*** * TECHNICAL INFORMATION NOTICE * ***

DATE: June 27, 2005
TO: Mitsubishi Motors Sales Managers, Parts Managers and Service Managers
RE: 2006 Eclipse Brake Master Cylinder Replacement
ATIN NO. TIN-05-SR-005

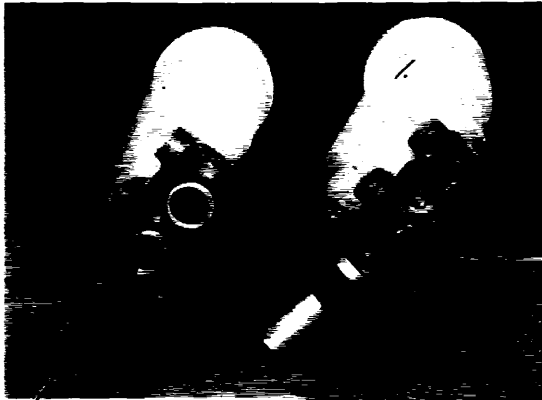
SR-05-003 instructs dealers to replace the master cylinder, using kit p/n 4625A027KT (A/T) or p/n 4625A028KT (M/T). Before removing the master cylinder from the customer's vehicle to perform the recall procedure, inspect the new replacement part provided in the kit. If the master cylinder replacement part has **two additional ports** (located on the bottom) that have black rubber plugs, **DO NOT USE THIS PART.** Immediately notify your facing PDC supervisor for assistance.

OK TO
USE

DO NOT USE IF
THE PART HAS
THESE
ADDITIONAL
PORTS
